Installation Monitoring Report

| Project | NW 2050 Cypress Point | Job Number | 24064 | RGC Number | N/A |
| Address | 7511, 7531, 7651 Minoru Boulevard Richmond, B.C. | Inspector | Matthew | Report Number | 03 |

3.1 **Building B**

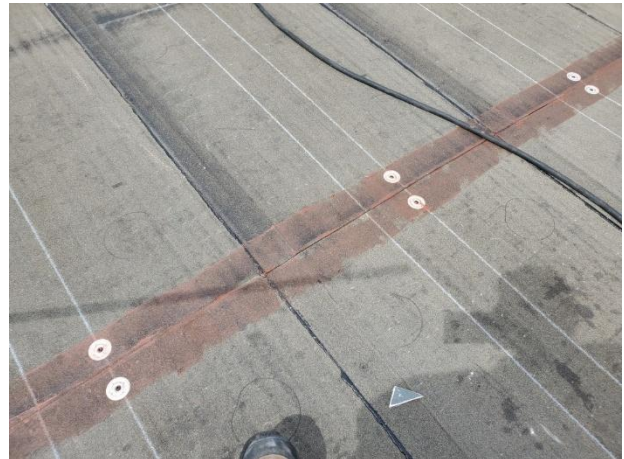
Crew have begun to lay out the Soprema 2n1 smartboard sanded with ½" HD ISO board along the North side on the center section of the roof.

3.6 **Building B**

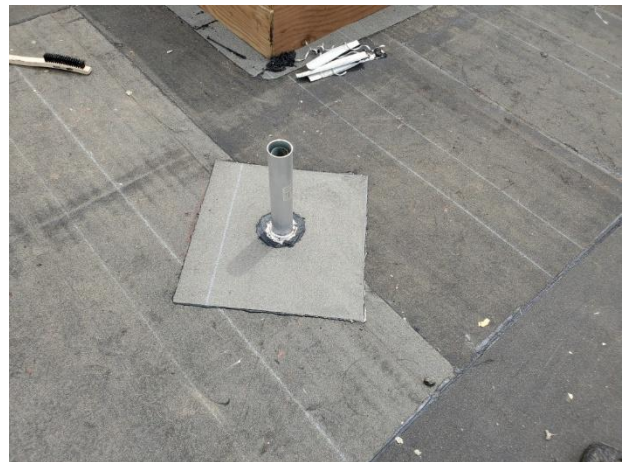
Multiple protrusion details are being worked on as per specifications.
